# **Lindon City Planning Commission Staff Report**

August 23, 2016

#### 6. Public Hearing — Street Master Plan Amendment (Approx. 1550 West 200 North...)

**RE: 1550 West Master Planned Roadway**

<p>ELEVATION DRAWINGS</p>	 <p>48 NORTH GENEVA OFFICE PARK OFFICE/WAREHOUSE PROJECT NEUGE</p>	 <p><b>BLUE STEEL ARCHITECTURE</b> Design Build LLC 1892 South 550 West - Payson, Utah - 801-592-8973</p>

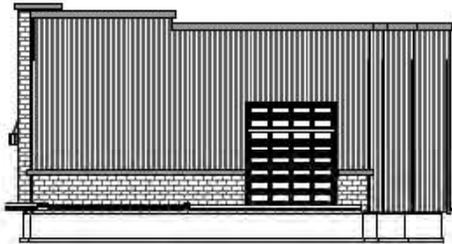
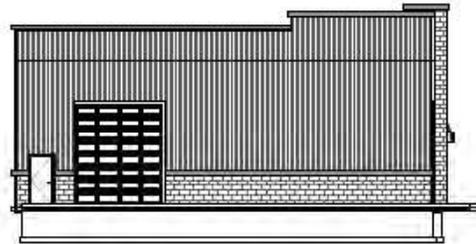
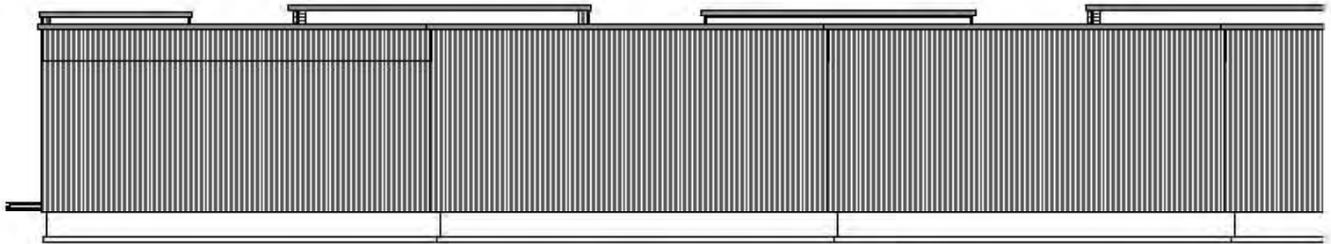
Lindon City Code 17.49.070 indicates that all buildings in the LI and HI zone shall be aesthetically pleasing, well-proportioned buildings, which blend with the surrounding property and structures. The building exterior includes the use of insulated panels with an embossed stucco pattern and Modera dry stack block for columns and wainscot. The elevations also include metal trim, store front aluminum clad windows and metal awnings. The Planning Commission may approve ribless, metal, flat-faced,

stucco embossed, metal sandwich panel buildings when the Planning Commission finds that the building is aesthetically pleasing, adequately trimmed, contrasted with different colors, is well proportioned, blends in with surrounding property, and has a similar look to that achieved by 17.49.070(1): incorporate the use of brick, decorative block, stucco, wood or other similar materials. The exterior appearance of such buildings shall primarily be of earth tone colors. The proposed color scheme is included in this report.

1. Recombine the parcels
2. Identify landscaping plan
3. Elevations

# LINDON CITY STREET MASTER PLAN MAP

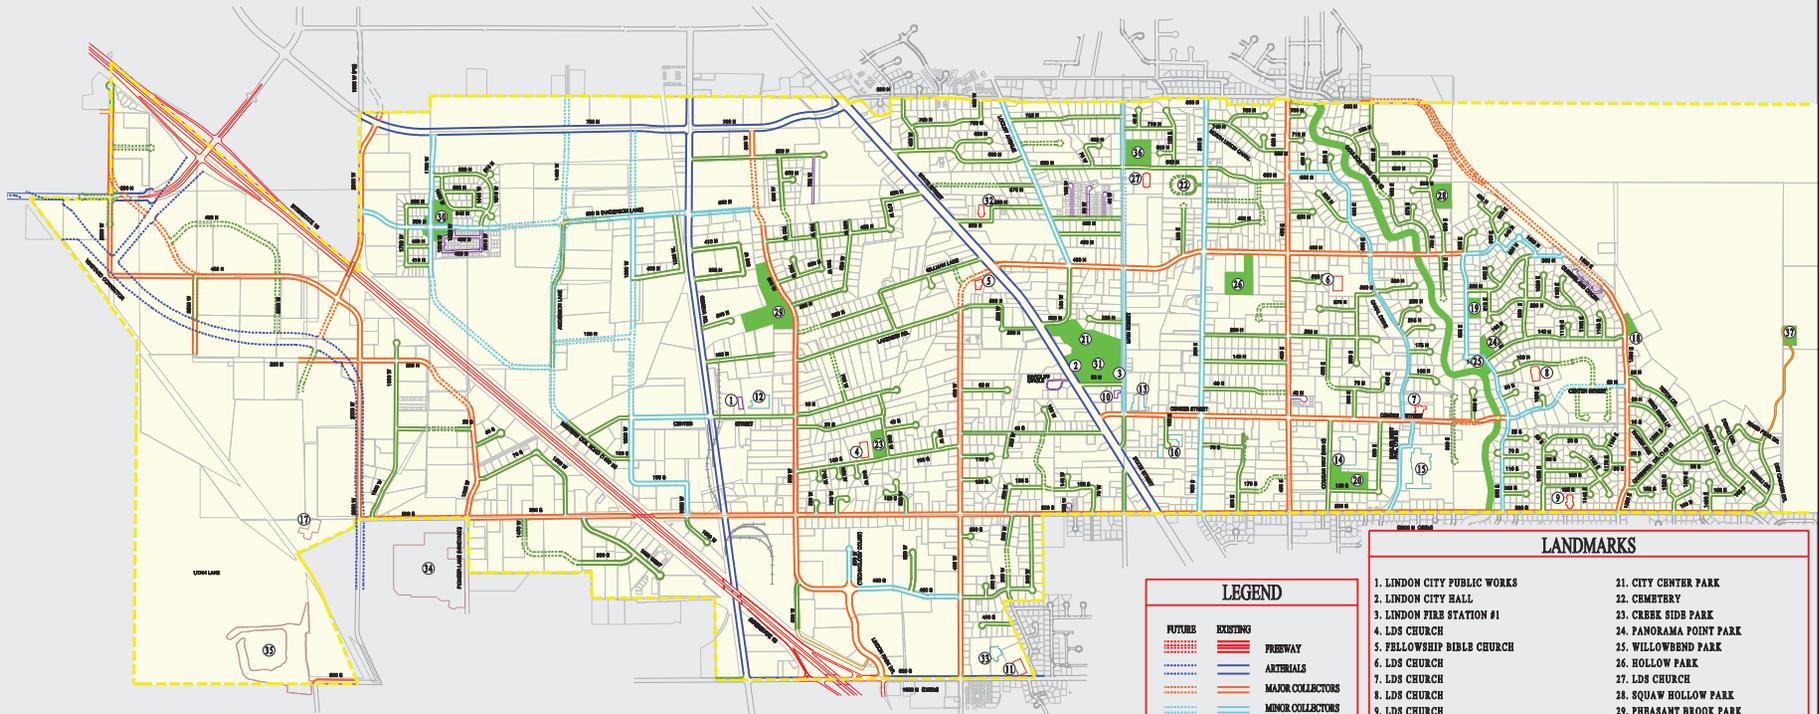
Hugh, Jocelynn and I discussed issues related to this issue this morning. Let me try to outline reasons we could see why it would or would not be a good idea. I haven't talked to Jocelynn since DRC Meeting, but I presume that their proposal is to put a turnaround at the end of the two streets that are stubbed to the property.

- A cul-de-sac on each end of the planned roadway can adequately provide access to the property, while meeting cul-de-sac length standards
- It would result in more developable area

- It would result in less infrastructure for the public to maintain
- It would allow more flexibility in the size and configuration of buildings that could be built in the area of the planned road

- It would create the connection between 1550 West and 1800 West at this time via 20 South
- It would (presumably) include construction of utilities in 20 South (which would make more land along it ready for development)

- It would spur development of the land that has been slow to develop, in part because of the narrow space between I-15 and the planned road
- The collector link may not be as necessary in the future anyway because of the future Vineyard Connector that will provide a highly functional way to get traffic from the 200 South area to the northwest area of Lindon near the interchange

- The water line could still be connected between the two cul-de-sacs if necessary for fire flow to proposed buildings (though this would put a water main on private property)

- It would eliminate that only alternate (to the Vineyard Connector) connection with a 50' wide road surface between 200 South and 2000 West
- It reduces connectivity of streets in the area (this might be more consequential if large office buildings are built there)
- It is the route of a planned buffered bike lane (though perhaps the buffered bike lane that was planned through the area could be replaced by another bicycle facility that provides continuous access through the land that road is planned to traverse)

- While we do not need the water line connection along the planned roadway to meet our level of service, having it creates a more robust system because of looping, creating the ability to keep more people in service when we have to shut down a section of line for repairs.
- If the road goes through, after everything is built and developed, we will probably never wish that the road did not go through; however, if it doesn't go through, there may be times that we wish the road did go through (traffic circulation, bike lane continuity, water looping, etc.)

1. Cash bond be placed for the construction of 20 South road and applicable utilities between 1550 West and the existing portion of 20 South.
2. Development agreement be executed between applicant, property owners along necessary 20 South right of way, and the City that guarantees the construction of 20 South.
